N60478.AR.000014  
NWS EARLE  
5090.3a

**State of New Jersey**  
**DEPARTMENT OF ENVIRONMENTAL PROTECTION**  
DIVISION OF WASTE MANAGEMENT  
HAZARDOUS SITE MITIGATION ADMINISTRATION  
CN 028, Trenton, N.J. 08625

RE: Naval Weapons Station Earle Health/Safety Plan and POAM by Weston

The following are the comments generated by the New Jersey Department of Environmental Protection after the review of the workplan by Weston for Naval Weapons Station Earle.

FIGURE 5 SITE 2 - ORDNANCE DEMILITARIZATION SITE

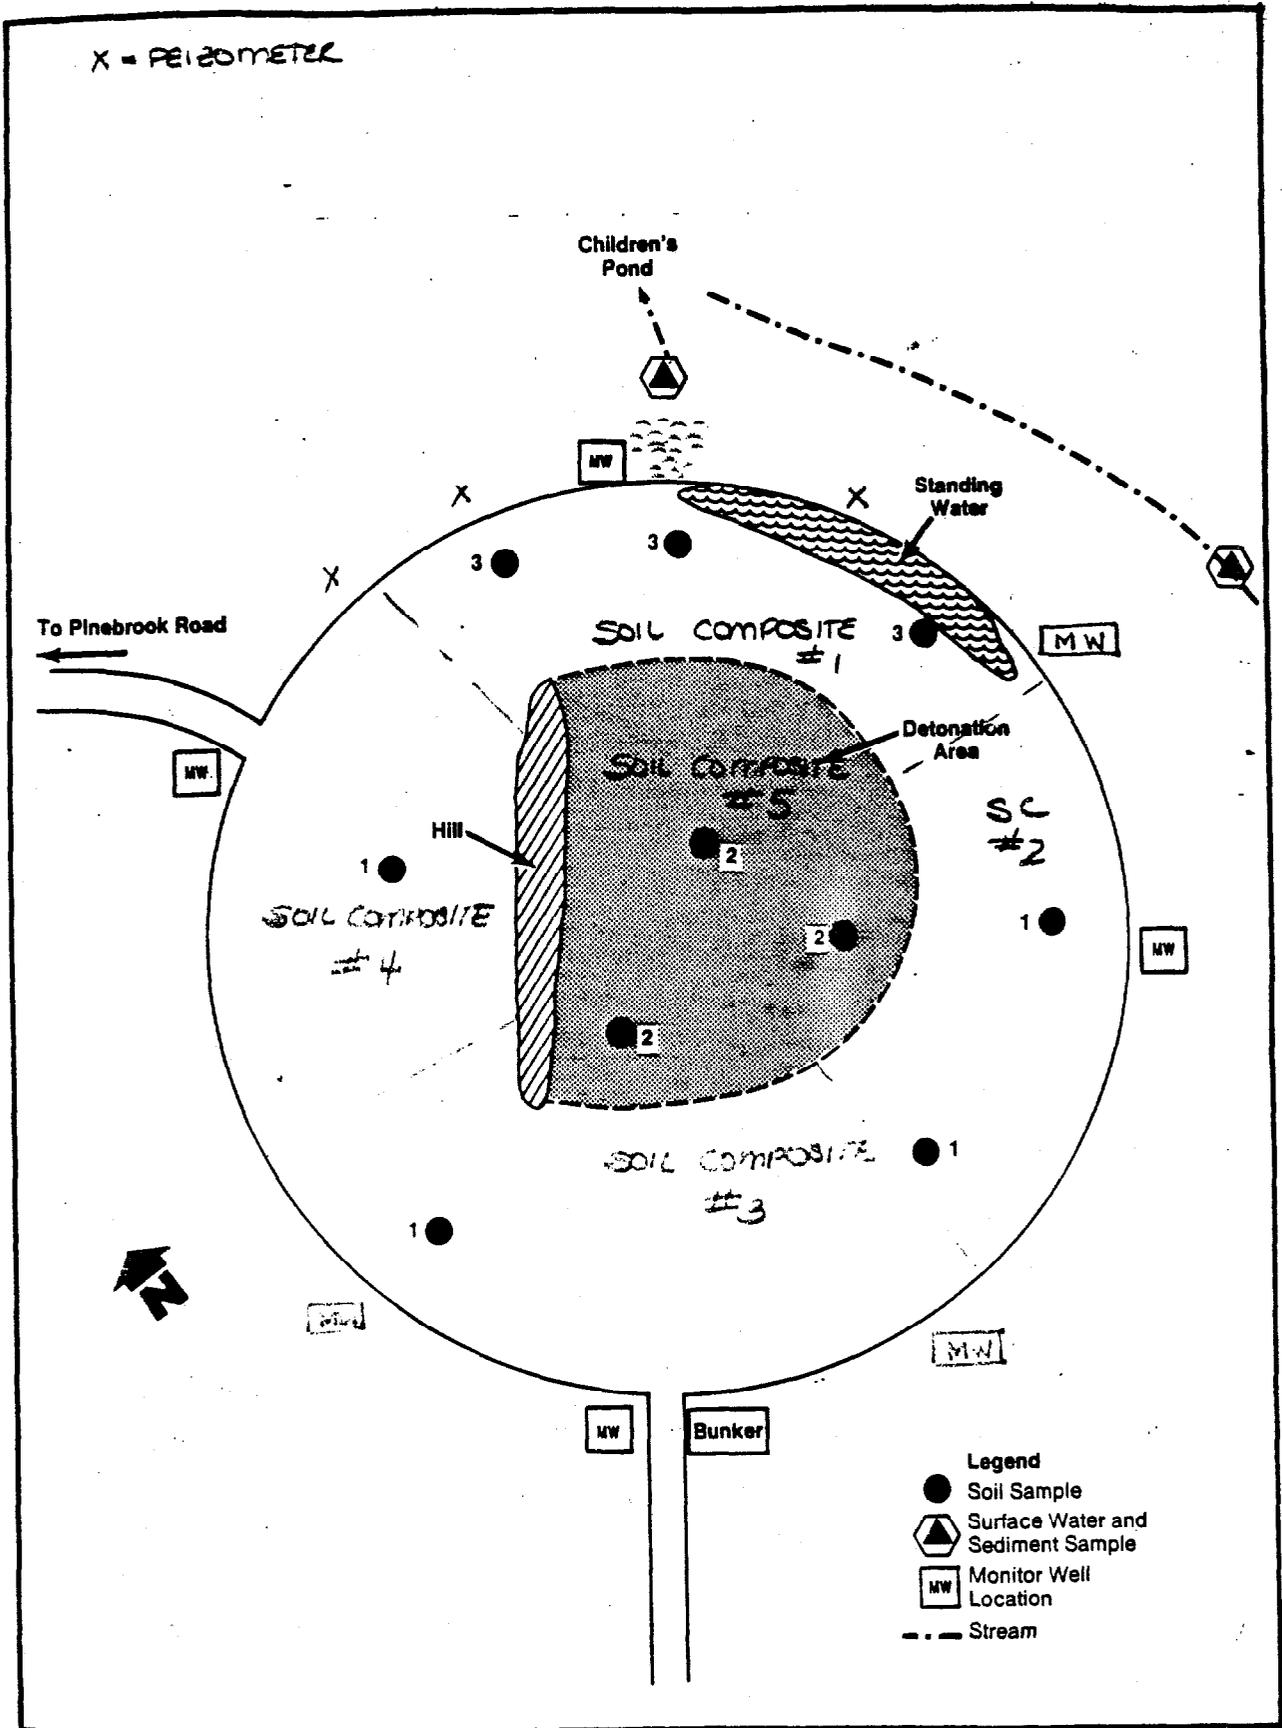
#### Site 2 - Ordinance Demilitarization

This site has been described as an eleven (11) acre site in which approximately 80,000 pounds of explosives and propellents have been disposed of. The proposed investigation consisting of four monitoring wells, three soil samples, and two surface water and sediment samples is inadequate to determine potential groundwater contamination. A combination of wells and peizometers have been recommended as in Figure 1. The six monitoring wells and three peizometers determine the site's groundwater quality and will validate (or invalidate) the assumptions of groundwater flow. There should be a minimum of five (5) composite soil samples taken from the site: one from the detonation area as was suggested, and the remaining circular area broken into quadrants for four (4) more composite samples. Rationale should be provided for sampling suggested. Refer to Figure 1. Stream direction should be indicated on the map and the two samples taken should be located upstream and downstream, respectively.

FIGURE 6 SITE 3 - LANDFILL SOUTHWEST OF "F" GROUP

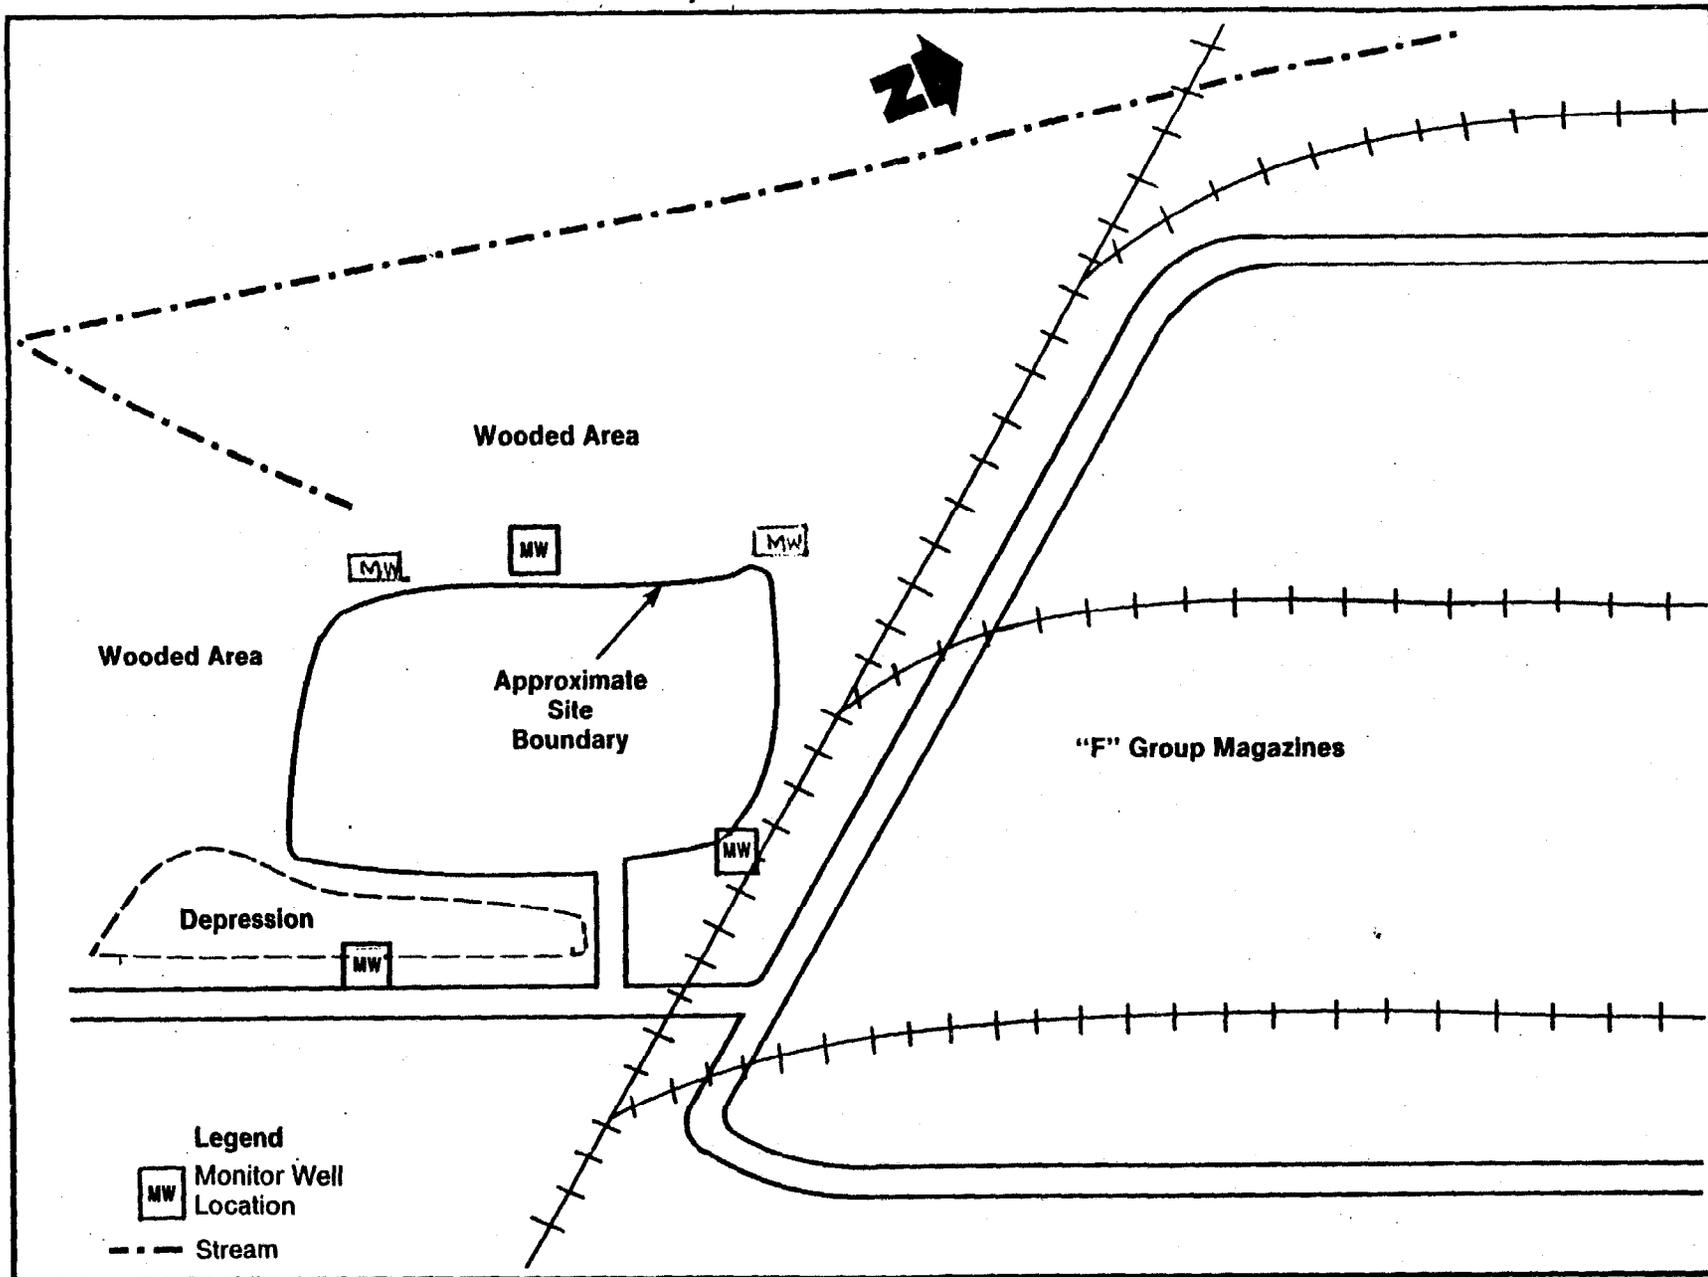
Two wells should be included as shown in Figure 2, and placement should occur as indicated.

FIGURE 7 SITE 4 LANDFILL WEST OF "D" GROUP

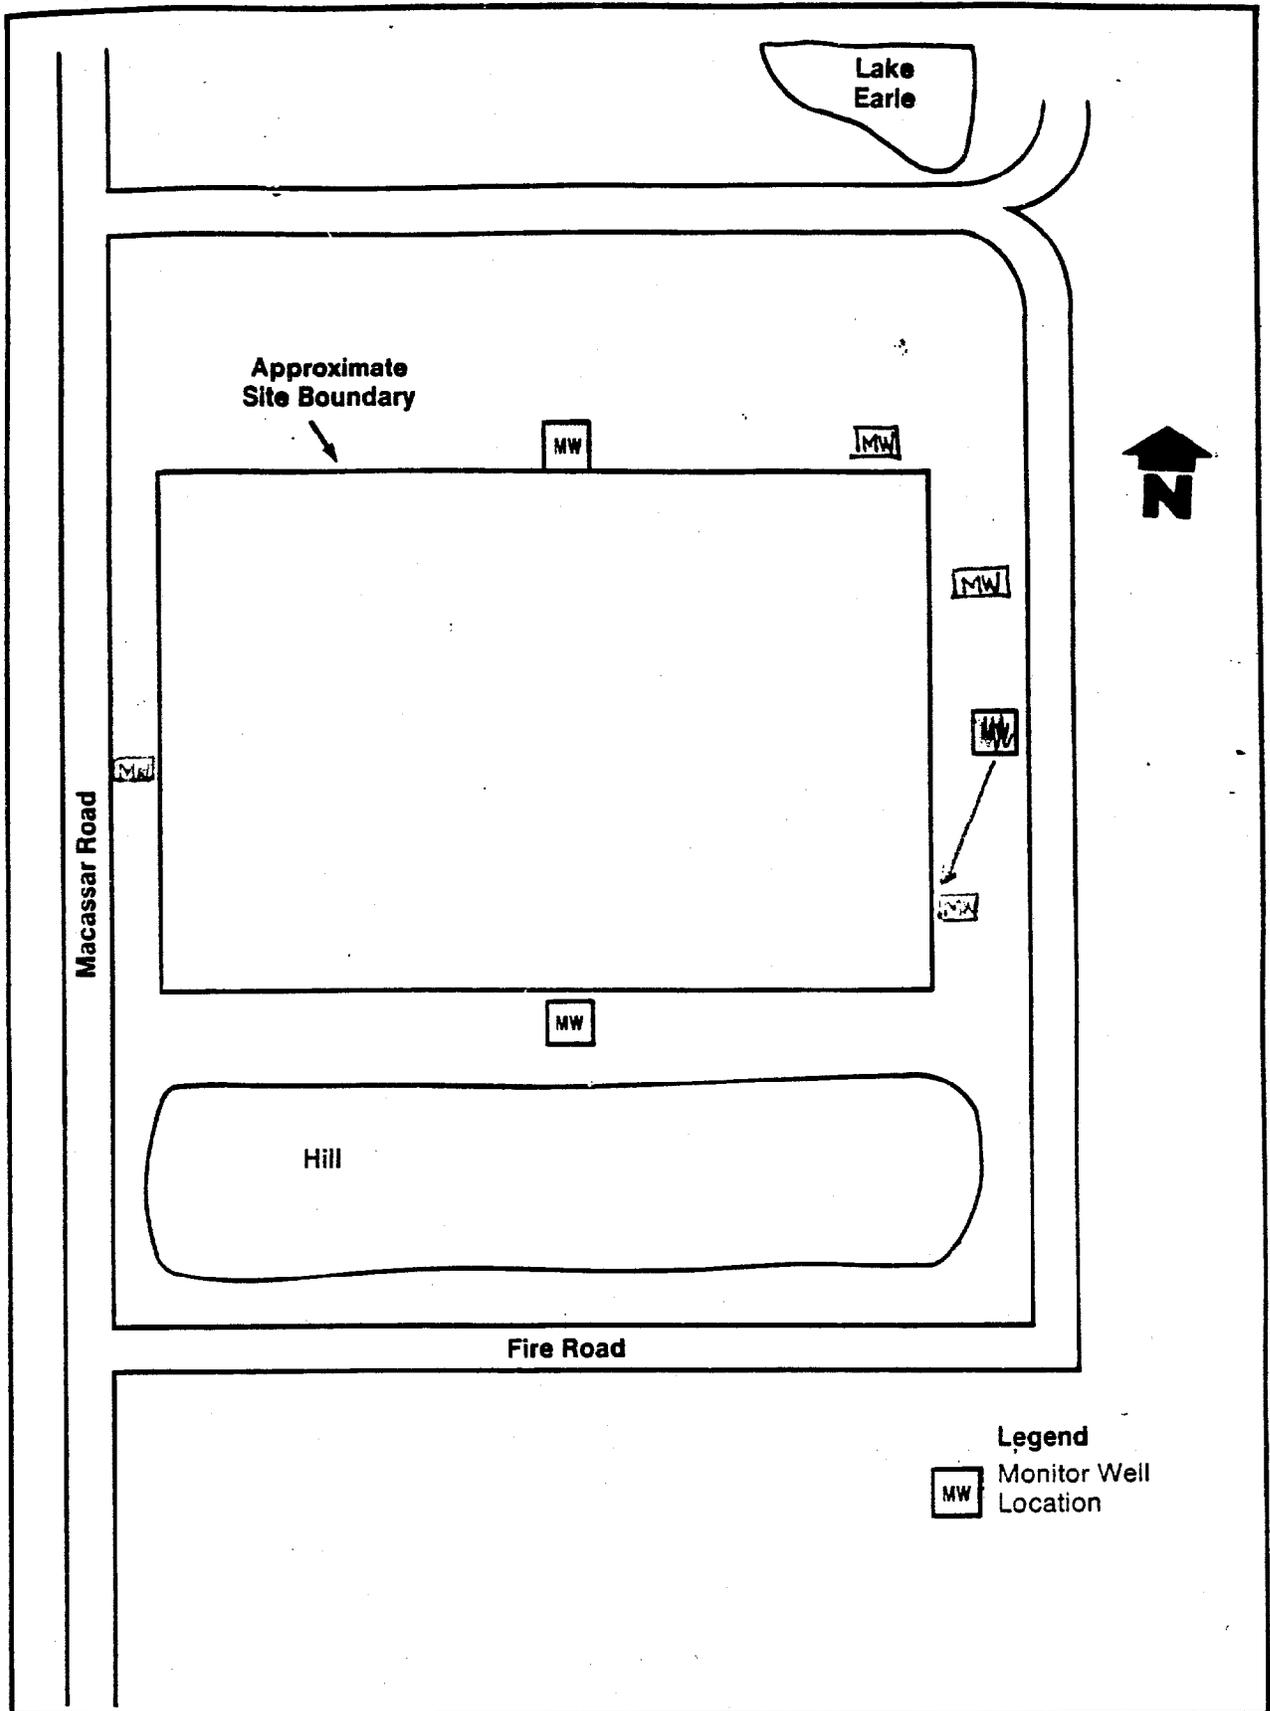
Please refer to figure 3. Two wells are to be added.

FIGURE 8 SITE 5 - LANDFILL WEST OF ARMY BARRICADES

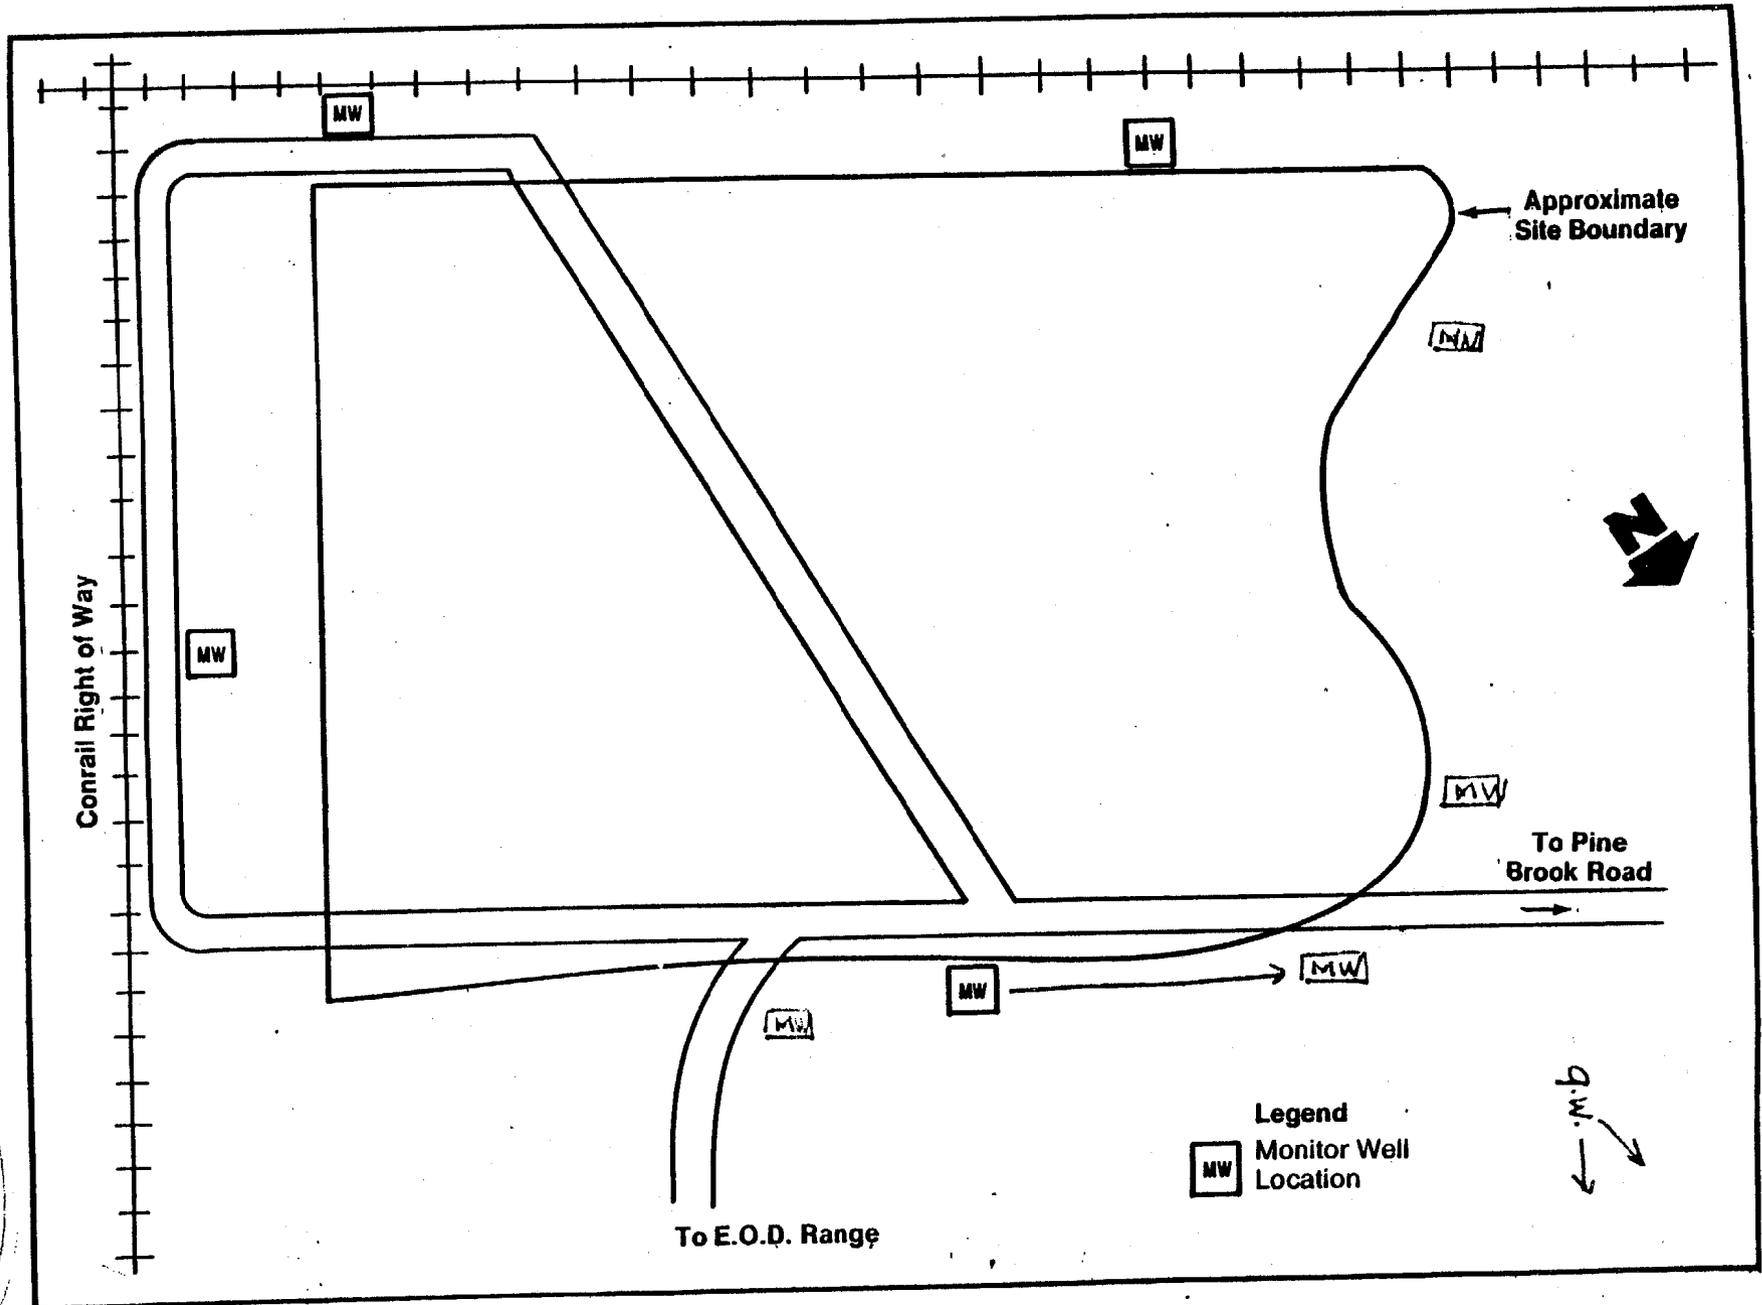
Three monitoring wells should be added. Refer to Figure 4.

FIGURE 9 SITE 10 - SCRAP METAL LANDFILL

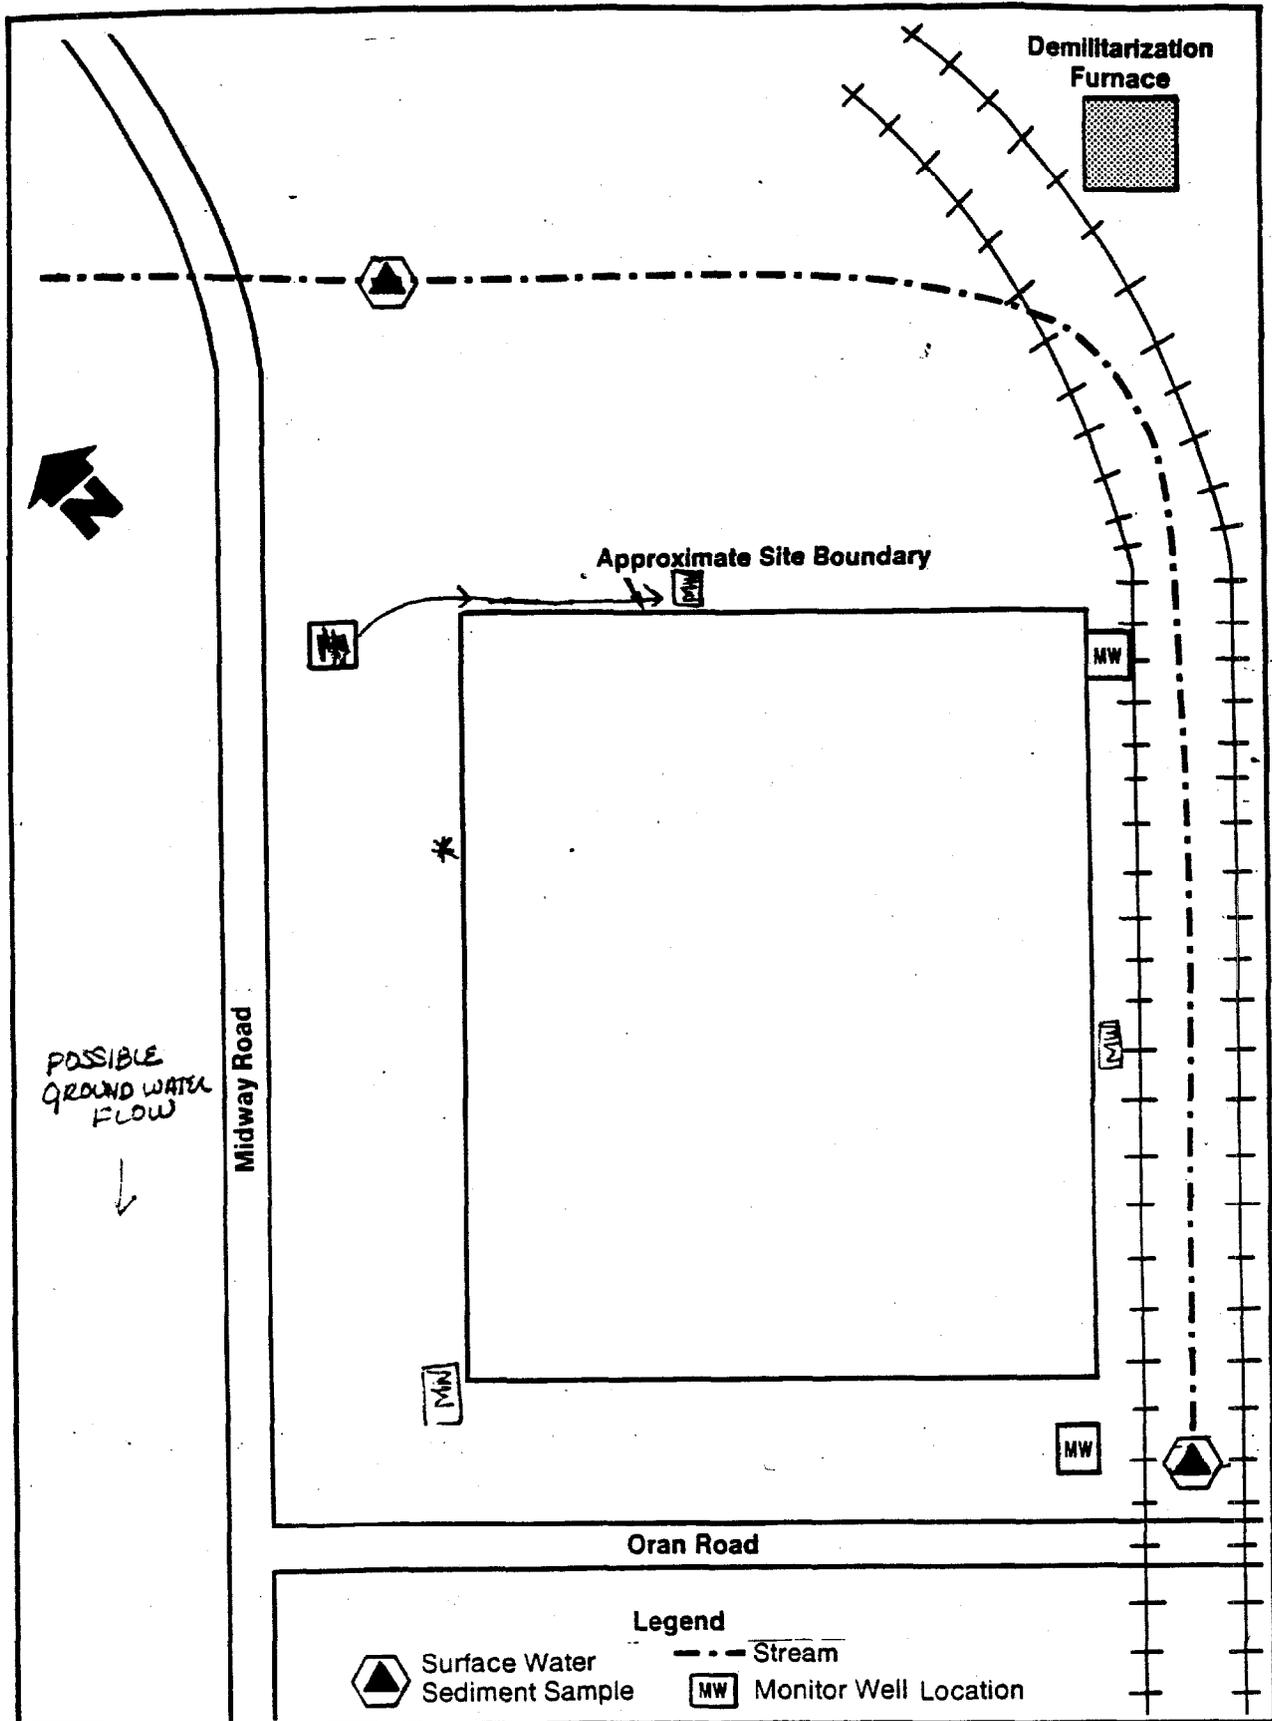
Two monitoring wells are to be added as indicated in Figure 5, as well as two peizometers in the position shown.
